SERVICE BULLETIN

M-1373C

August 1, 2014

2014 TOURING ABS BRAKE LINE - SAFETY RECALL 0157

Figure 1. ABS Brake Line Cable Straps

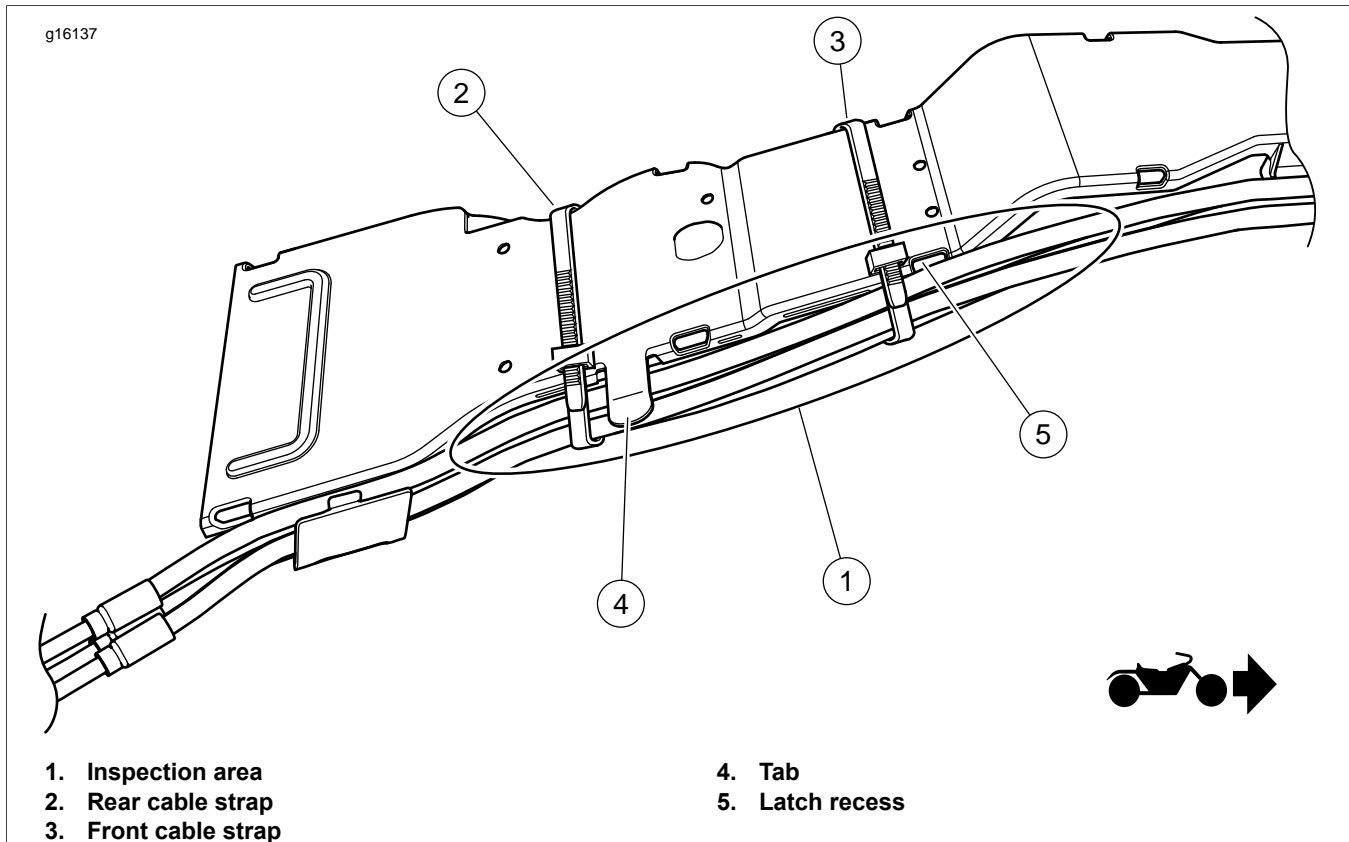
2. Remove the seat and fuel tank. See the service manual.
3. See Figure 1. Inspect brake line routing along the wire trough. Verify that the lines are secured by two cable straps (2, 3) as shown. Motorcycles built October 14, 2013 and later will have the rear cable strap (2) already installed. Installed cable straps may be black or white in color. Both are acceptable.

4. If lines are not secured by cable straps:
 - a. Inspect lines for damage in area (1).
 - b. If line is damaged, refer to Table 2 to determine if replacement is necessary. If line replacement is required, see the service manual. The **new** line can be taken from dealer inventory or ordered using the included order form.

- c. Verify that lines are properly routed under tab (4).
 - d. Secure lines with one or two **new** cable straps (2, 3) (Part No. 10039) as required. Locate rear cable strap (2) within 1/2 in (13 mm) rearward of tab (4). Locate front cable strap (3) at or near latch recess (5).
